# KINGSTATE ELECTRONICS CORPORATION

## PRODUCT CHANGE NOTICE:

We hereby announce that the part no.: KTG1205C has been executed with a

change. The updated product will be: KTG1205C VERSION: TKS-7184-2.4

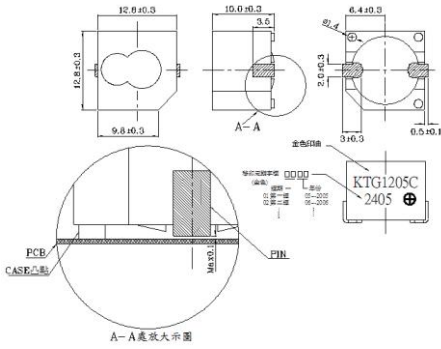
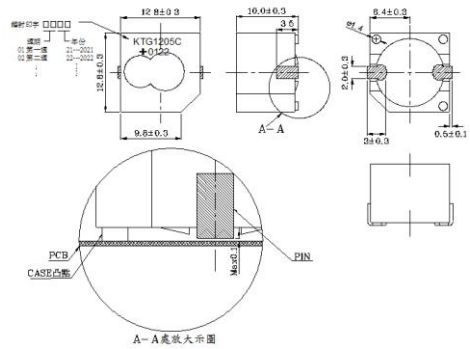
Change	Before	After
<p><u>外觀變更 Change of product appearance</u></p> <p>正面:舊結構無印字, 新結構鐳射印字</p> <p>Front side: the old structure is without printing and the new structure is laser printing.</p>		
<p>側面:舊結構金色印字, 新結構無印字</p> <p>Side view: old structure is golden printing and new structure is without printing.</p>		
<p>背面 :舊結構環氧表面側光看有兩個电子零件痕跡 ; 新結構環氧表面側光看有一個电子零件痕跡</p> <p>Back view: old structure has two electronic component traces on the epoxy surface, new structure has one electronic component trace.</p>

<p>Reverse side: The epoxy surface of the old structure has two traces of electronic parts seen from the side light, while the epoxy surface of the old structure has one trace of electronic part seen from the side light.</p>																																
<p>内部结构: 舊結構為雙三極管結構 新結構為 IC 結構 Internal structure: The old structure is a double triode structure and the new structure is IC structure.</p>																																
<p>Change</p>	<p>Before</p>	<p>After</p>																														
<p>外观尺寸说明: <u>变更前后尺寸无差异</u> About appearance and size: There is no difference in size before and after the change.</p>																																
<p>Change content 特性: <u>变更前后特性无差异</u> About characteristics: There is no difference in the characteristics before and after the change.</p>	<table border="1" data-bbox="568 1391 1011 1637"> <tr> <td>Rated Voltage<sup>↙</sup> 額定電壓<sup>↙</sup></td> <td>V<sub>DC</sub><sup>↙</sup></td> <td>5.0<sup>↙</sup></td> </tr> <tr> <td>Operating Volt.<sup>↙</sup> 操作電壓<sup>↙</sup></td> <td>V<sub>DC</sub><sup>↙</sup></td> <td>4.0~7.0<sup>↙</sup></td> </tr> <tr> <td>Mean Current<sup>↙</sup> 平均耗電流<sup>↙</sup></td> <td>mA<sup>↙</sup></td> <td>Max. 30<sup>↙</sup></td> </tr> <tr> <td>Sound Output<sup>↙</sup> 輸出音壓<sup>↙</sup></td> <td>dBA<sup>↙</sup></td> <td>Min. 90<sup>↙</sup> (Typical 94)<sup>↙</sup></td> </tr> <tr> <td>Resonant Frequency<sup>↙</sup> 谐振頻率<sup>↙</sup></td> <td>Hz<sup>↙</sup></td> <td>2400 ± 300<sup>↙</sup></td> </tr> </table>	Rated Voltage <sup>↙</sup> 額定電壓 <sup>↙</sup>	V <sub>DC</sub> <sup>↙</sup>	5.0 <sup>↙</sup>	Operating Volt. <sup>↙</sup> 操作電壓 <sup>↙</sup>	V <sub>DC</sub> <sup>↙</sup>	4.0~7.0 <sup>↙</sup>	Mean Current <sup>↙</sup> 平均耗電流 <sup>↙</sup>	mA <sup>↙</sup>	Max. 30 <sup>↙</sup>	Sound Output <sup>↙</sup> 輸出音壓 <sup>↙</sup>	dBA <sup>↙</sup>	Min. 90 <sup>↙</sup> (Typical 94) <sup>↙</sup>	Resonant Frequency <sup>↙</sup> 谐振頻率 <sup>↙</sup>	Hz <sup>↙</sup>	2400 ± 300 <sup>↙</sup>	<table border="1" data-bbox="1042 1391 1513 1637"> <tr> <td>Rated Voltage<sup>↙</sup> 額定電壓<sup>↙</sup></td> <td>V<sub>DC</sub><sup>↙</sup></td> <td>5.0<sup>↙</sup></td> </tr> <tr> <td>Operating Volt.<sup>↙</sup> 操作電壓<sup>↙</sup></td> <td>V<sub>DC</sub><sup>↙</sup></td> <td>4.0~7.0<sup>↙</sup></td> </tr> <tr> <td>Mean Current<sup>↙</sup> 平均耗電流<sup>↙</sup></td> <td>mA<sup>↙</sup></td> <td>Max. 30<sup>↙</sup></td> </tr> <tr> <td>Sound Output<sup>↙</sup> 輸出音壓<sup>↙</sup></td> <td>dBA<sup>↙</sup></td> <td>Min. 90<sup>↙</sup> (Typical 94)<sup>↙</sup></td> </tr> <tr> <td>Resonant Frequency<sup>↙</sup> 谐振頻率<sup>↙</sup></td> <td>Hz<sup>↙</sup></td> <td>2400 ± 300<sup>↙</sup></td> </tr> </table>	Rated Voltage <sup>↙</sup> 額定電壓 <sup>↙</sup>	V <sub>DC</sub> <sup>↙</sup>	5.0 <sup>↙</sup>	Operating Volt. <sup>↙</sup> 操作電壓 <sup>↙</sup>	V <sub>DC</sub> <sup>↙</sup>	4.0~7.0 <sup>↙</sup>	Mean Current <sup>↙</sup> 平均耗電流 <sup>↙</sup>	mA <sup>↙</sup>	Max. 30 <sup>↙</sup>	Sound Output <sup>↙</sup> 輸出音壓 <sup>↙</sup>	dBA <sup>↙</sup>	Min. 90 <sup>↙</sup> (Typical 94) <sup>↙</sup>	Resonant Frequency <sup>↙</sup> 谐振頻率 <sup>↙</sup>	Hz <sup>↙</sup>	2400 ± 300 <sup>↙</sup>
